**SUBJECT:** RAPID RESPONSE TRANSMITTAL SERVICE ACTION # 06-030  
Cowl Stud Sealing Patch

**INVOLVED VEHICLES:** 2006 (XK) Commander

1. INSPECT HEAD OF STUD INSIDE COWL PLENUM FOR SEALING PATCH

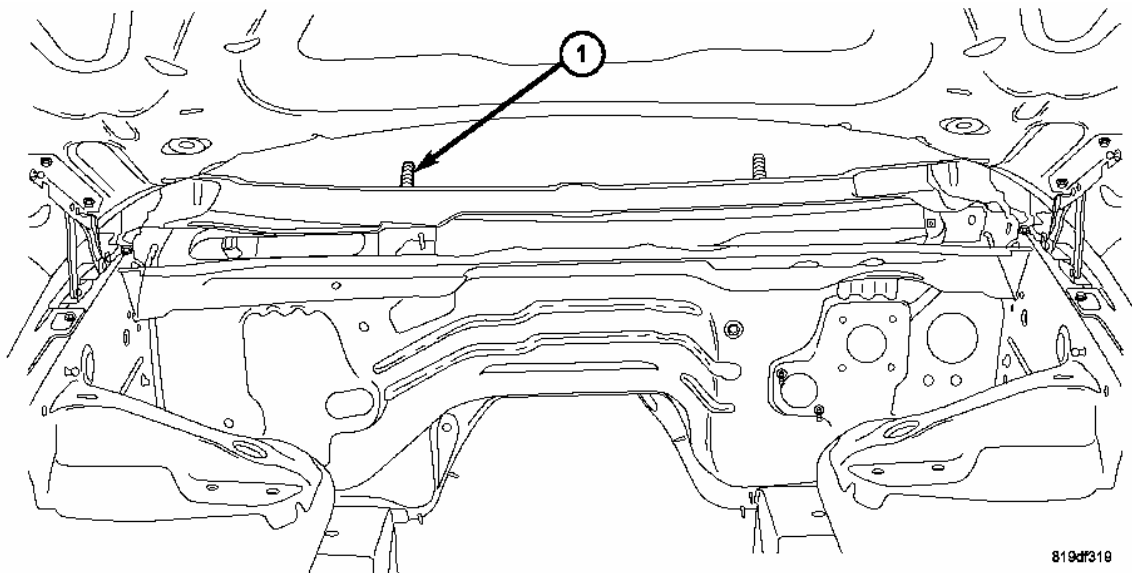
A number of vehicles may have been shipped with a cowl stud sealing patch that is not completely adhered.

4. There should be a 38 mm x 38 mm (1.5 in. x 1.5 in.) 1 mm (.040 in.) thick mastic patch inside the cowl plenum over the head of this stud.
5. If patch is hanging, secure existing patch by pressurizing over stud head. If patch is fully adhered, no additional action required.
6. If patch is missing, apply patch, p/n 04278178, over the head of the stud.
7. Locate the missing patch within the plenum/HVAC area and discard.
8. Install the cowl screen.
9. With the wiper motor in the park position, install the windshield wiper arms so that the lower edge of the blade is aligned with the wiper alignment lines concealed in the upper margin of the lower windshield blackout area. Tighten the nuts to 21 N·m (16 ft. lbs.).
